UNITED STATES
DEPARTMENT OF THE INTERIOR
BUREAU OF LAND MANAGEMENT
APPLICATION FOR PERMIT TO DRILL OR REENTER

1a. Type of work: <input checked="" type="checkbox"/> DRILL <input type="checkbox"/> REENTER 1b. Type of Well: <input checked="" type="checkbox"/> Oil Well <input type="checkbox"/> Gas Well <input type="checkbox"/> Other 1c. Type of Completion: <input type="checkbox"/> Hydraulic Fracturing <input type="checkbox"/> Single Zone <input checked="" type="checkbox"/> Multiple Zone		5. Lease Serial No. NMNM90 6. If Indian, Allottee or Tribe Name 7. If Unit or CA Agreement, Name and No. 8. Lease Name and Well No. AMAZING 19 FED <div style="text-align: center;">[333115]</div> 801H 9. API Well No. 30-025-52074

PECOS DISTRICT DRILLING CONDITIONS OF APPROVAL

OPERATOR'S NAME:	EOG RESOURCES INCORPORATED
WELL NAME & NO.:	AMAZING 19 FED 801H
SURFACE HOLE FOOTAGE:	371'/N & 1359'/E
BOTTOM HOLE FOOTAGE:	100'/S & 660'/E
LOCATION:	Section 19, T.22 S., R.32 E., NMP
COUNTY:	Lea County, New Mexico

**Proposed Wellbore
Design A**

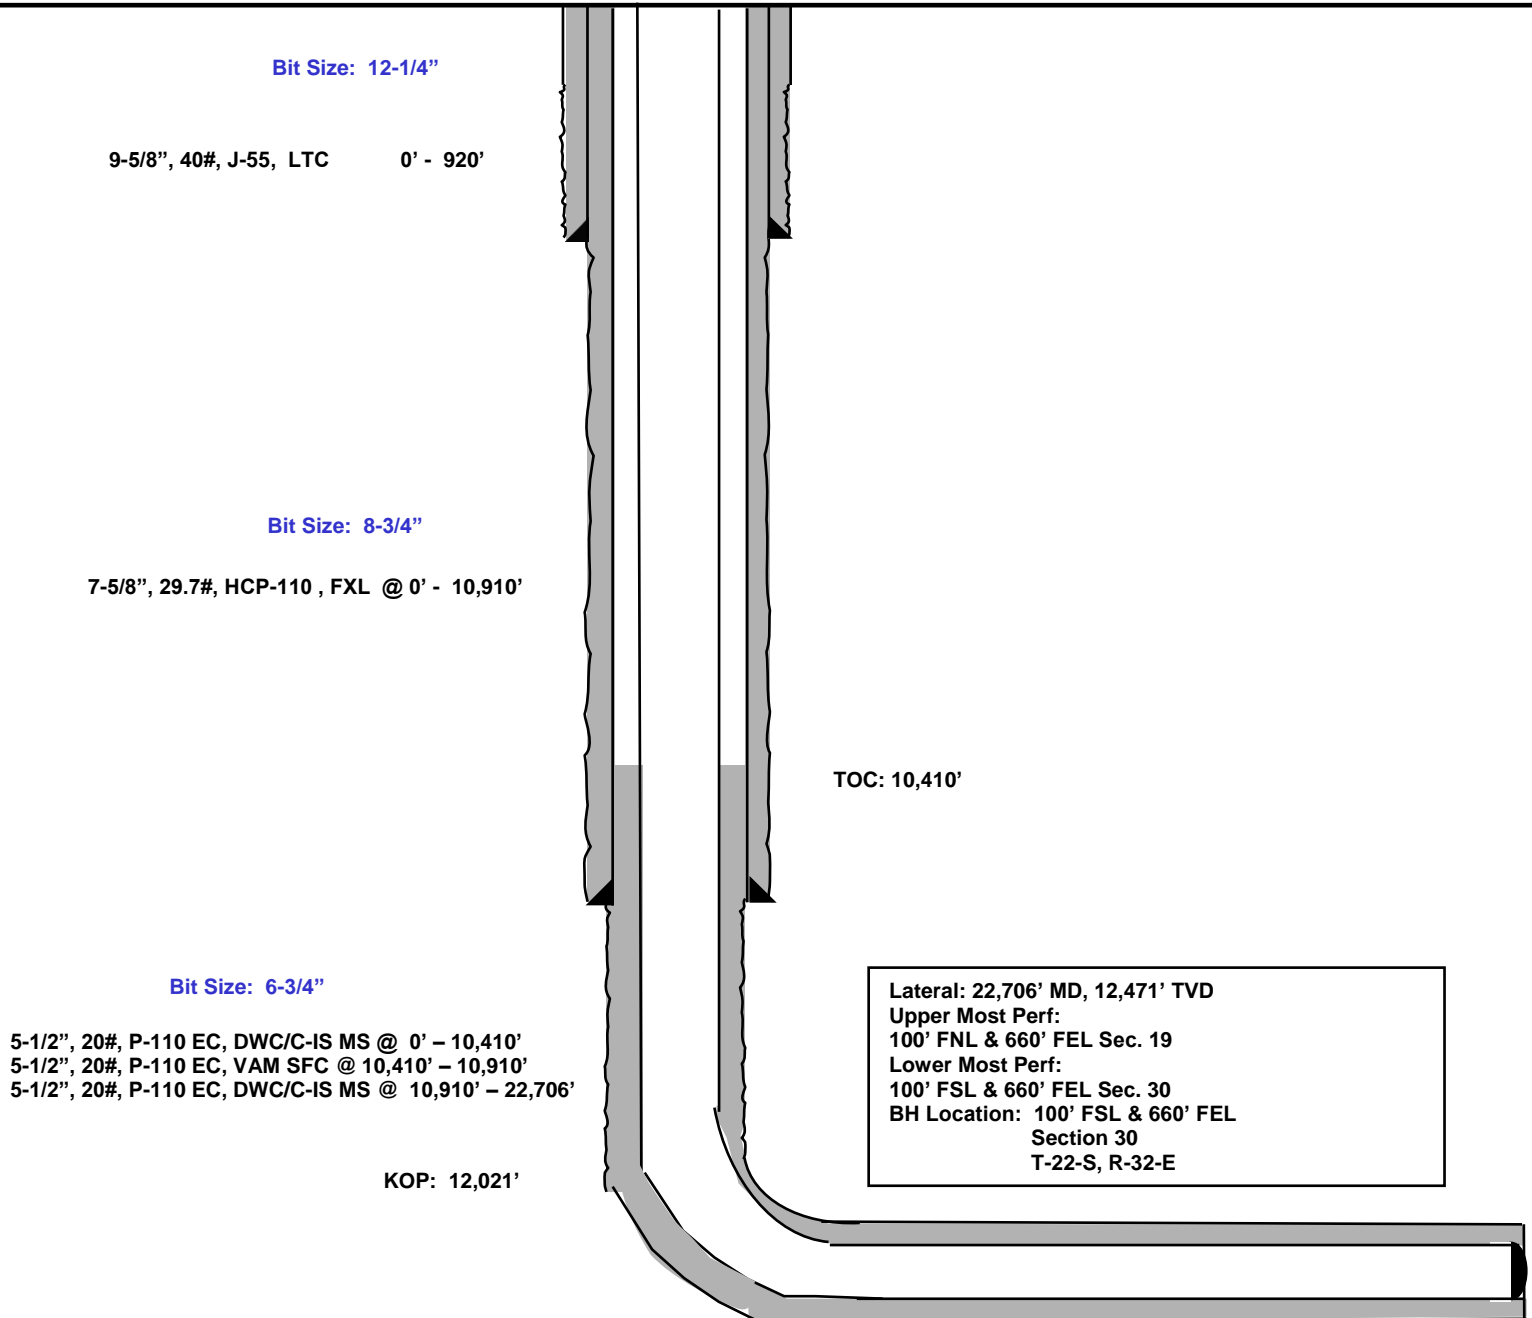
Operator has proposed to pump down 9-5/8" X 7-5/8" annulus after primary cementing stage. Operator must run Echo-meter to verify Cement Slurry/Fluid top in the annulus Or operator shall run a CBL from TD of the 7-5/8" casing to surface after the second stage BH to verify TOC.

3. The minimum required fill of cement behind the **5-1/2** inch production casing is:
 - Cement should tie-back at least **200 feet** into previous casing string due to operator not meeting casing clearance requirement per 43 CFR 3170. Operator shall provide method of verification.

Proposed Wellbore
Design B

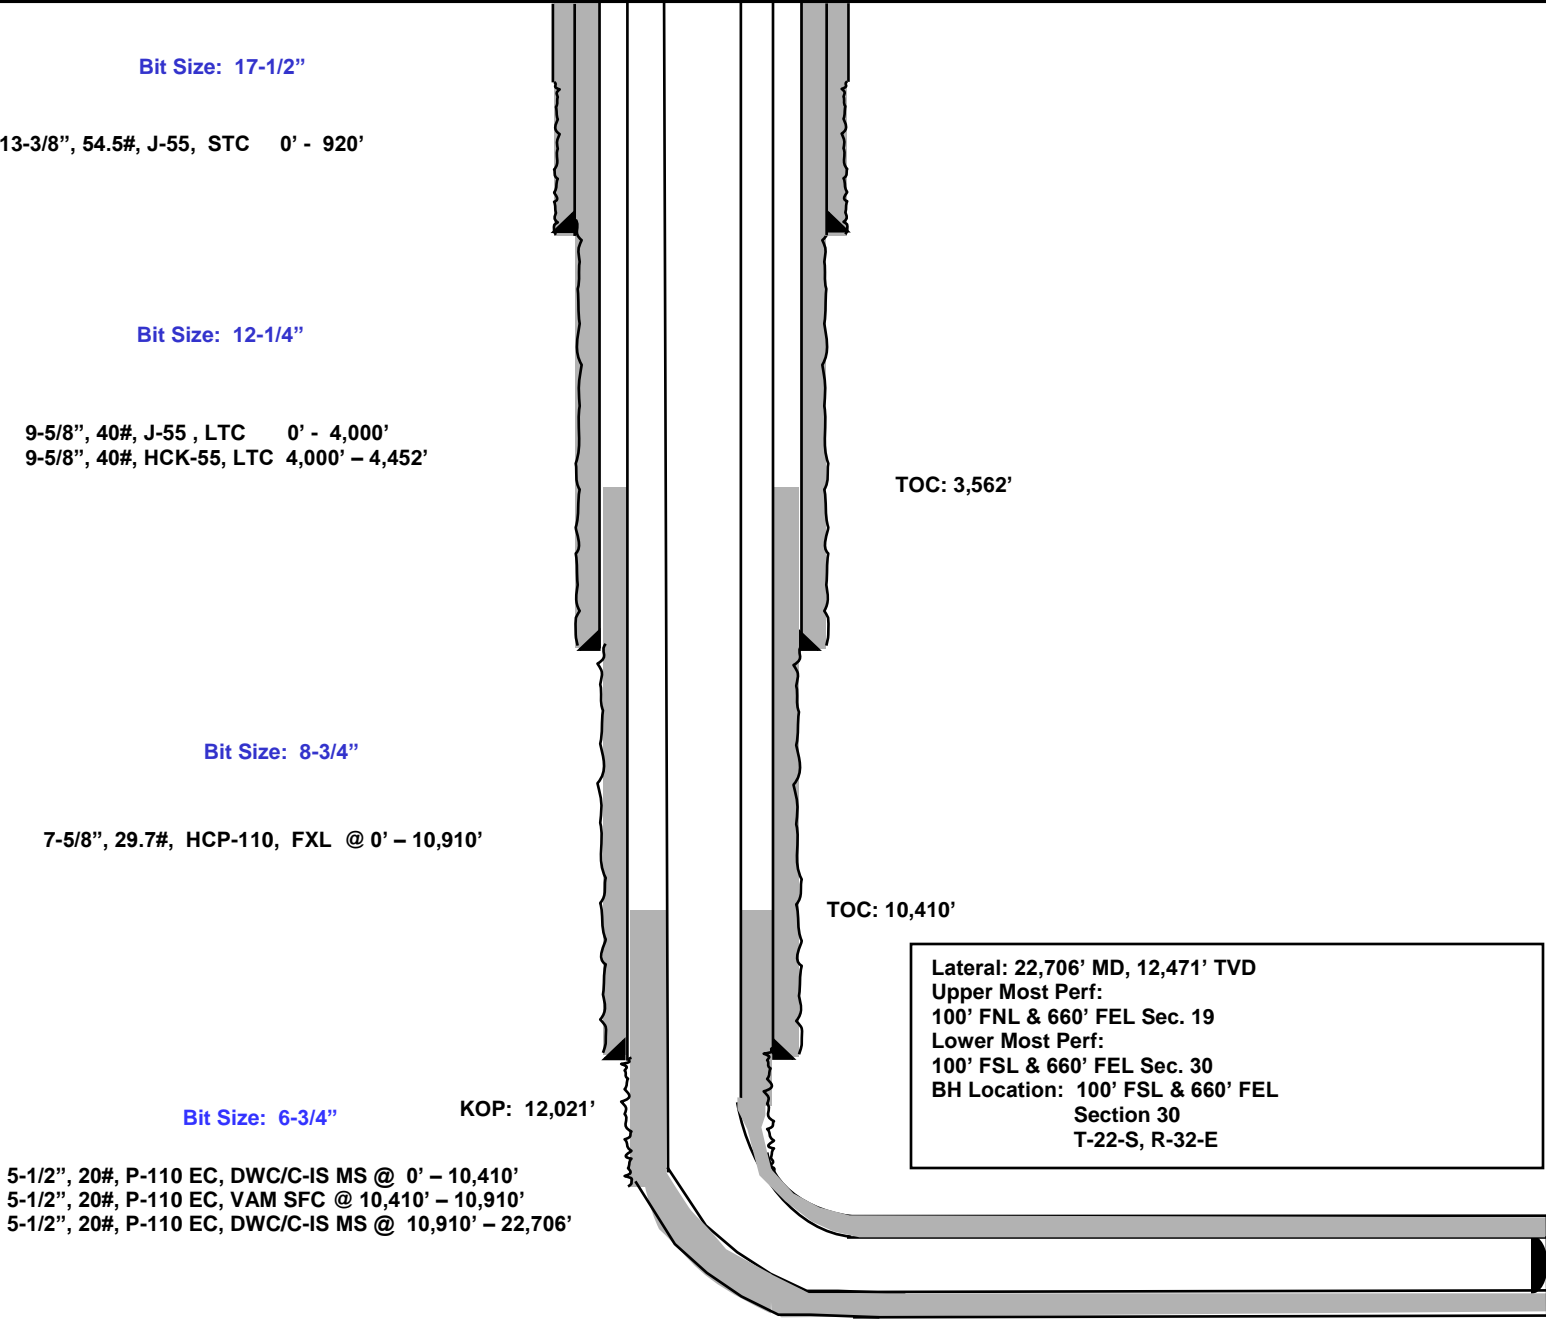
Operator is only approved for Design A. Design B is not to be utilized. If Design B is needed or any other change, please submit a NOI sundry to make the changes.
